Explosives Site Plan
Amendment 2

Military Munitions Response Program
Remedial Investigation/Feasibility Study

Camp Forsyth Landfill Area 2 Munitions Response Site
Fort Riley, Kansas

Amendment 2 to the Department of Defense Explosives Safety Board (DDESB) approved “*Military Munitions Response Program Remedial Investigation/Feasibility Study, Camp Forsyth Landfill Area 2 Munitions Response Site, Fort Riley, Kansas,*” dated March 2012, is submitted to include:

Ammendment 2 Map 2 Explosives Site Plan (ESP) Republican River Investigative Area

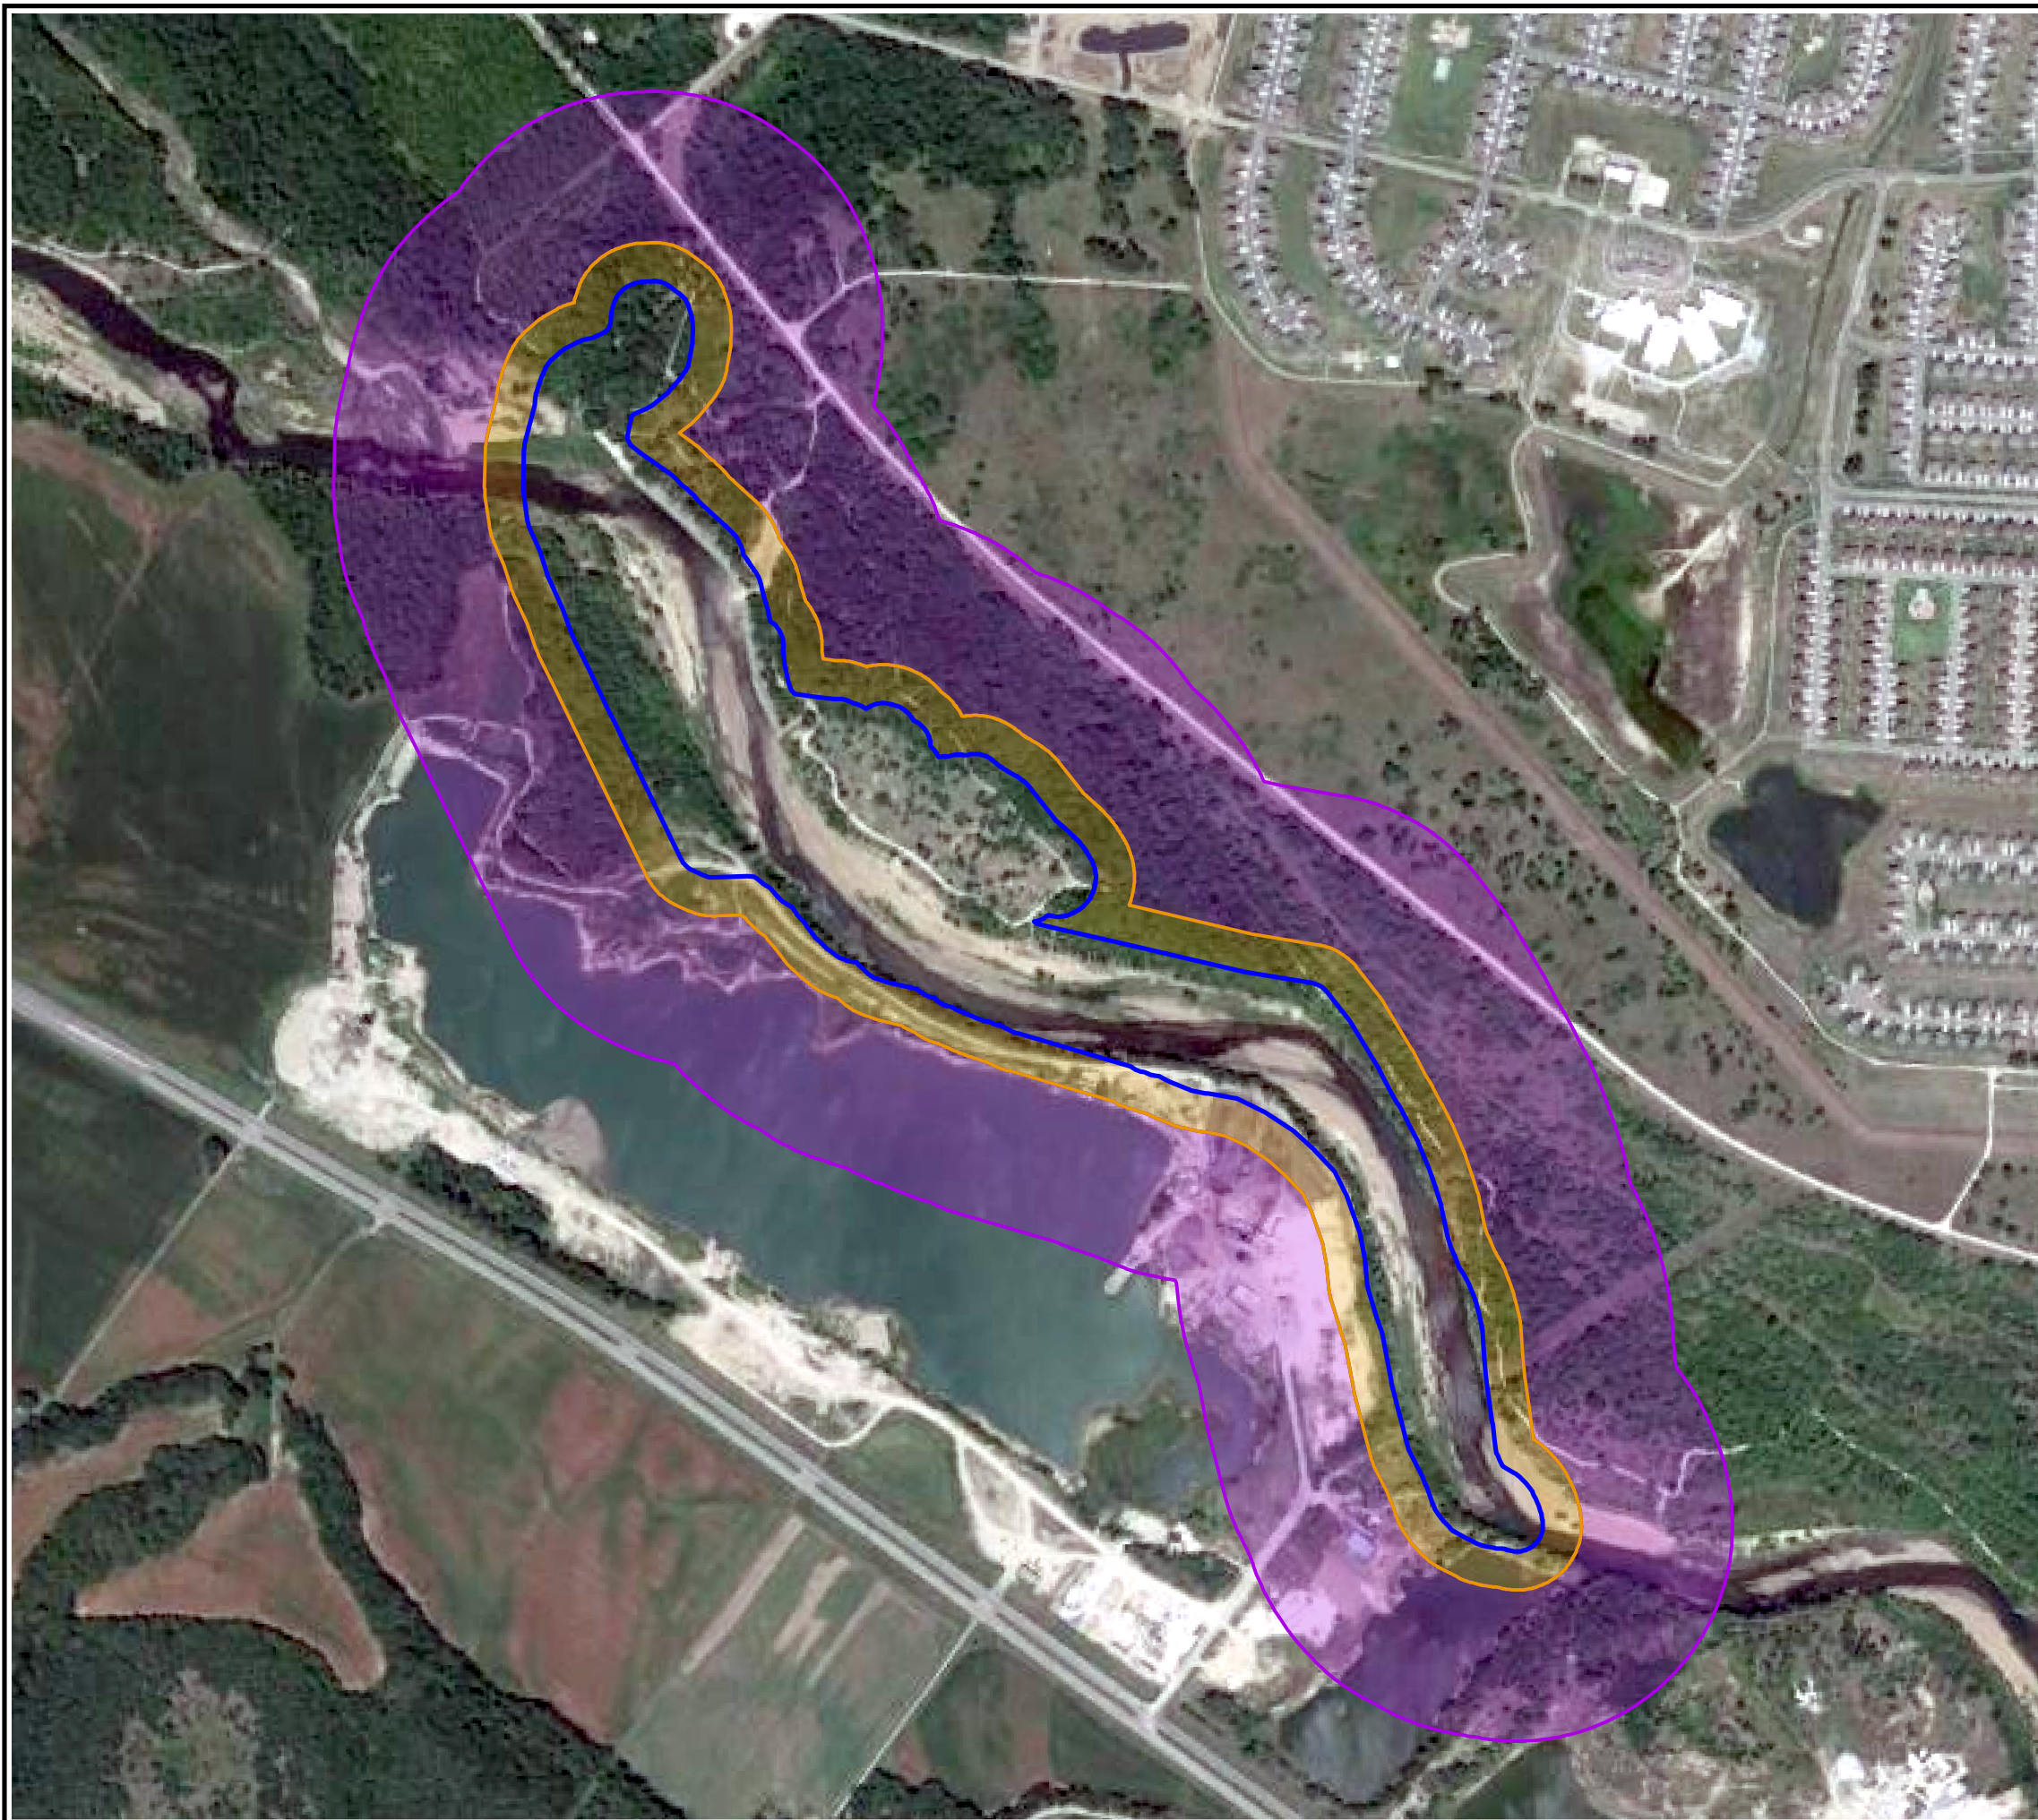
Table 6-1 describes the scope of the investigation. **Map 2** depicts the CFLFA 2 MRS - **Republican River Investigative Area** and **Map 3** depicts the CFLFA 2 MRS - **Breakneck Creek Investigative Area**.

The MGF in **the Republican River Investigative Area** is the M28A2, 3.5-inch Anti-Tank Rocket (M28A2) Map 2).

-  Republican River (92 Acres)
-  HFD - 157 Ft, MSD for Unintentional Detonation
-  MFD-H - 772 Ft, MSD for Intentional Detonation

Ammendment 2 Map 3 Explosives Site Plan (ESP) Breakneck Creek Investigative Area

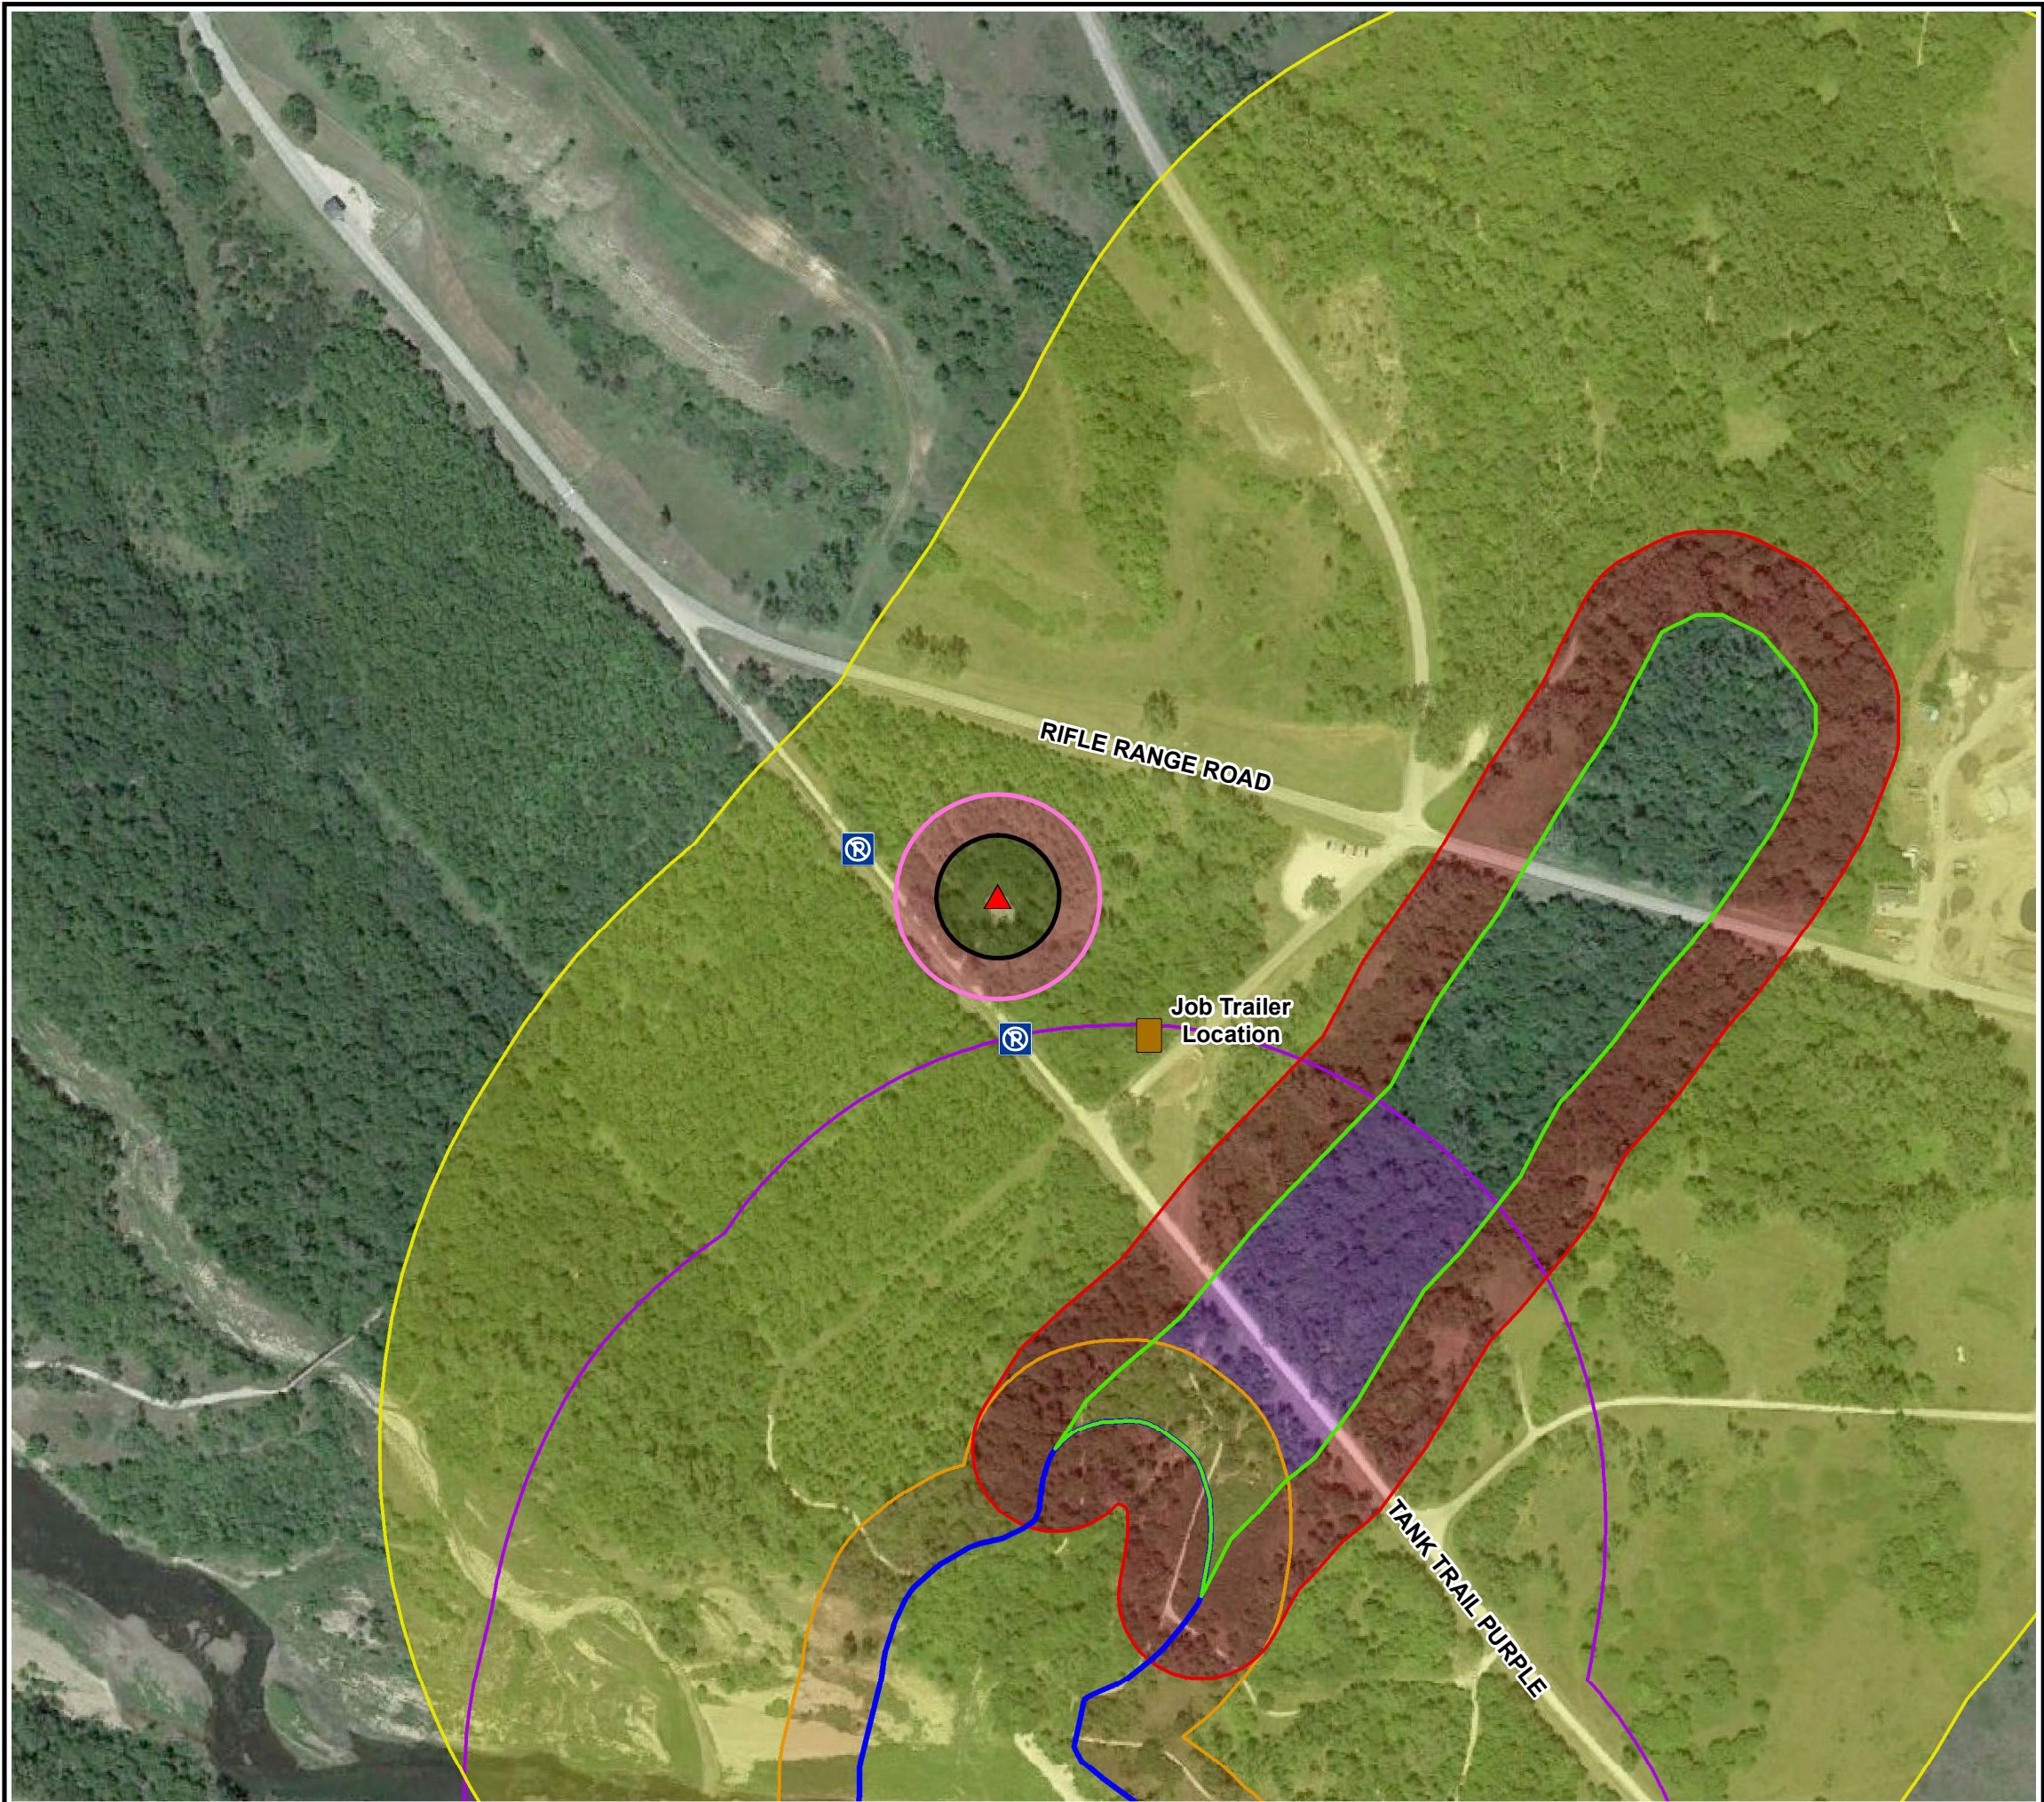
The additional area required for investigation on Breakneck Creek (Map 3) is 3.5 acres. A buffer zone has been added to the MRS to allow for step-out grids. The additional investigative area with buffer comprises 16 acres approximately 300 feet wide centered on Breakneck Creek by 1,760 feet long, beginning at the downstream side of the Breakneck Creek outfall at Tank Trail Purple.

The MGF in the Breakneck Creek Investigative Area is the M49 series 60 mm mortar because an M49A3 was recovered immediately downstream of the Breakneck Creek outfall at Tank Trail Purple during the 2014 RI (Map 3). The M49A5 has been ruled out because it was fielded after military training ceased at the MRS.

-  Breakneck Creek (16 Acres)
-  HFD - 162 Ft, MSD for Unintentional Detonation
-  MFD-H - 1,322 Ft, MSD for Intentional Detonation
